Technical Service Bulletin - TBJ011

Product: All R-22 units with TXVs

Issue:

INSTRUCTIONS FOR TXV POWER HEAD REPLACEMENT

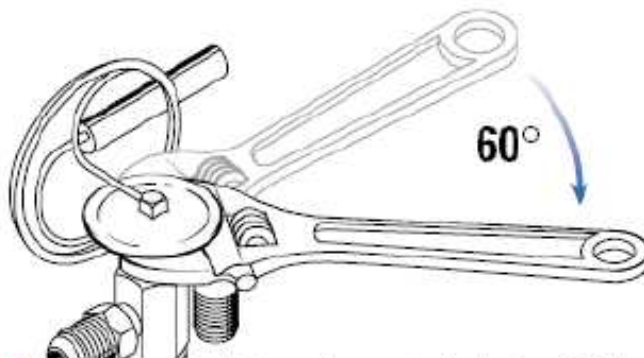
5 (Oil) Lubricate lock ring surface.

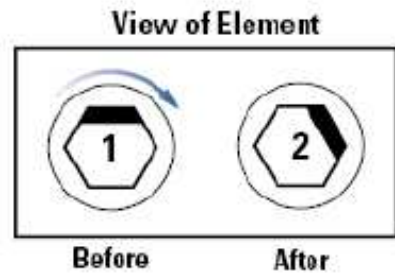
6 Hand tighten element.

7 After hand tight, turn element clockwise 60° (or movement equal to one hex flat).
